**ON-SITE SEWAGE DISPOSAL SYSTEM
 HOWARD COUNTY HEALTH DEPARTMENT
 BUREAU OF ENVIRONMENTAL HEALTH
 3525-H ELLICOTT MILLS DRIVE, ELLICOTT CITY, MD 21043**

FOUNDATION LOCATION	
LOT 6	
FOX CREEK SUBDIVISION	
HOWARD COUNTY MARYLAND

Approved Septic System Plan
 Howard County Health Department

NVHomes
 FOX CREEK SUBDIVISION
 LOT 6

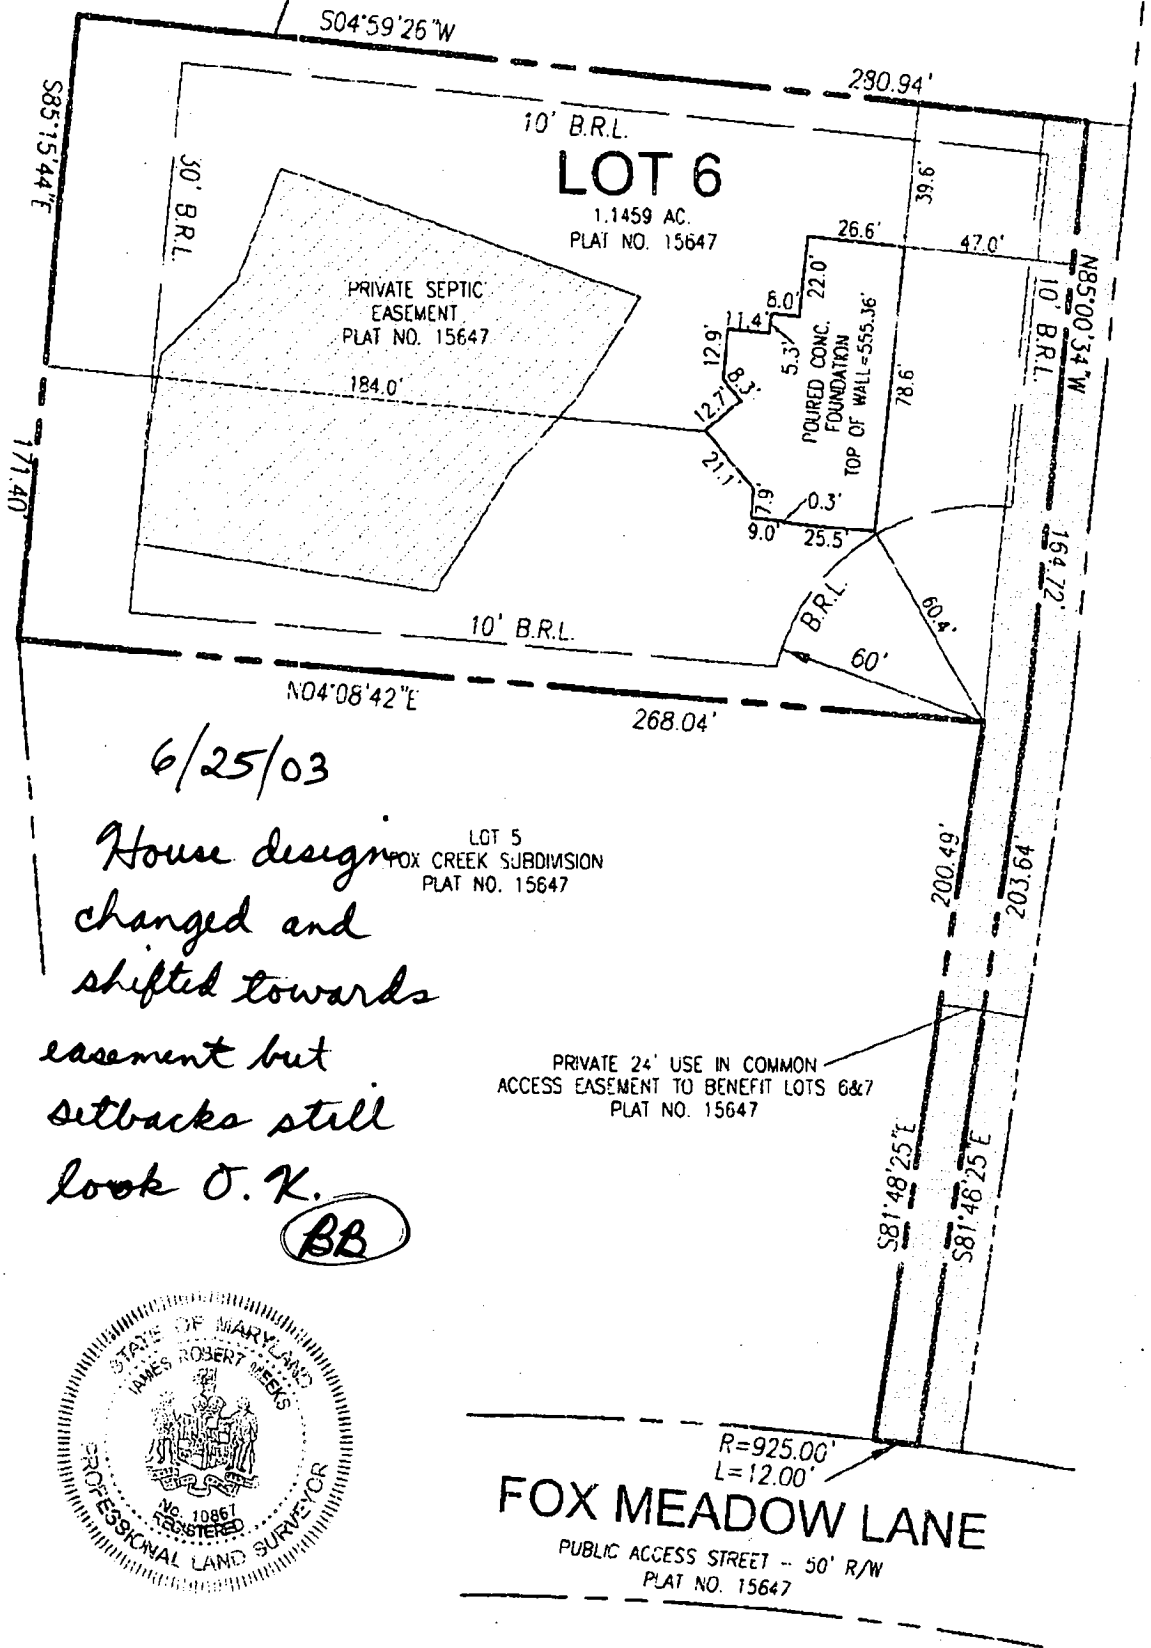
6/25/03
 House design
 changed and
 shifted towards
 easement but
 setbacks still
 look O.K.
 BB

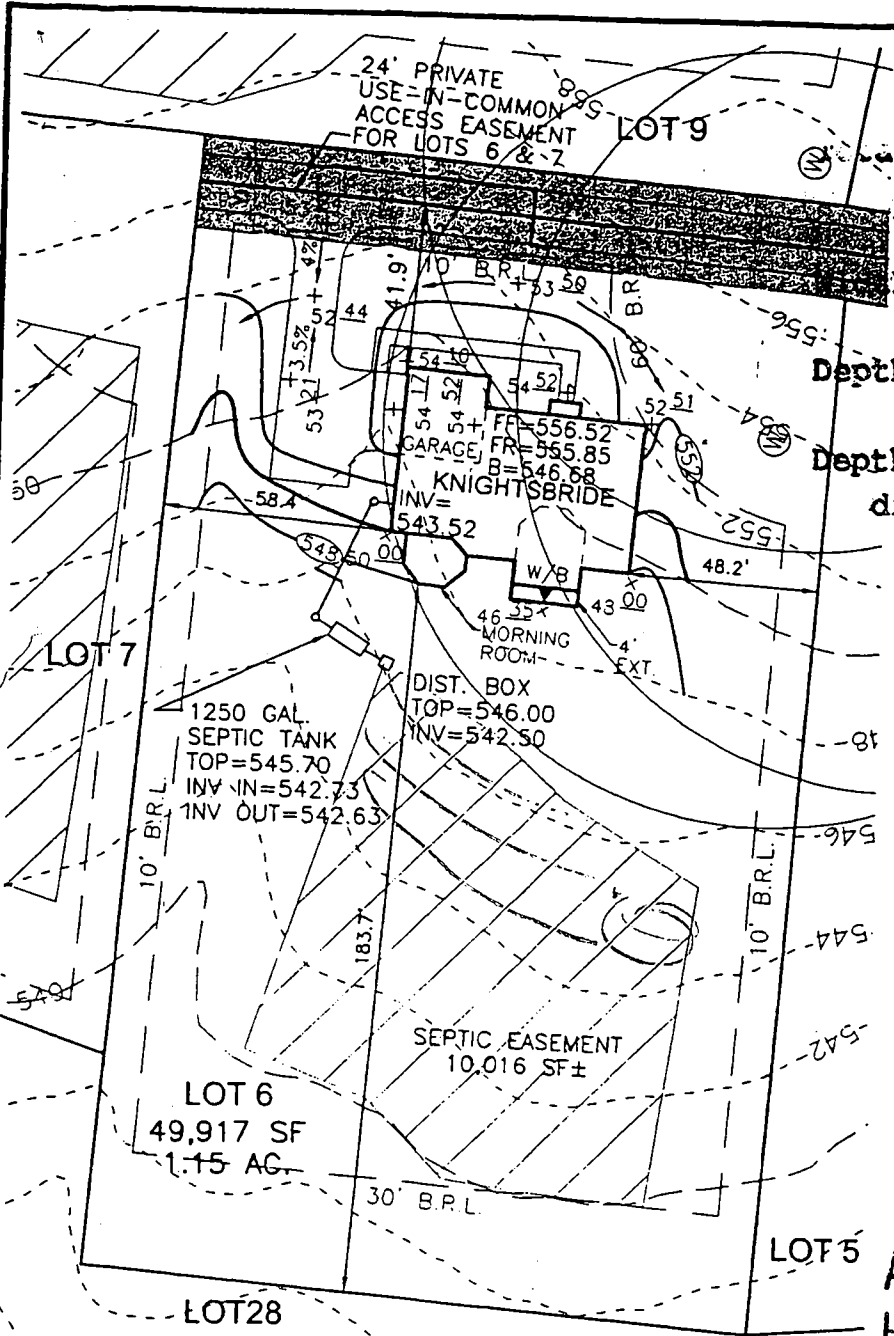
PRE-CONSTRUCTION 7/21/03 SRA staked, house changed, D.B. may be 6" shallow because of track path around house. Install 60'/80'/100' on best contour.

INSTALLATION S.T. may be further off house to keep it less than 3' deep (S)

7/22/03 INSTALLING a 60' x 80' & 100' trenches as per 80. Discussed with Mr. Van Sant location of nearby well radius. - confirmed. S.T. NOT in swale. OK TO CONTINUE. cover 1st trench when done. Sails match trench specs (KN)

ADDITIONAL NOTES: Adjust septic tank location during installation, so as to not be in the swale.
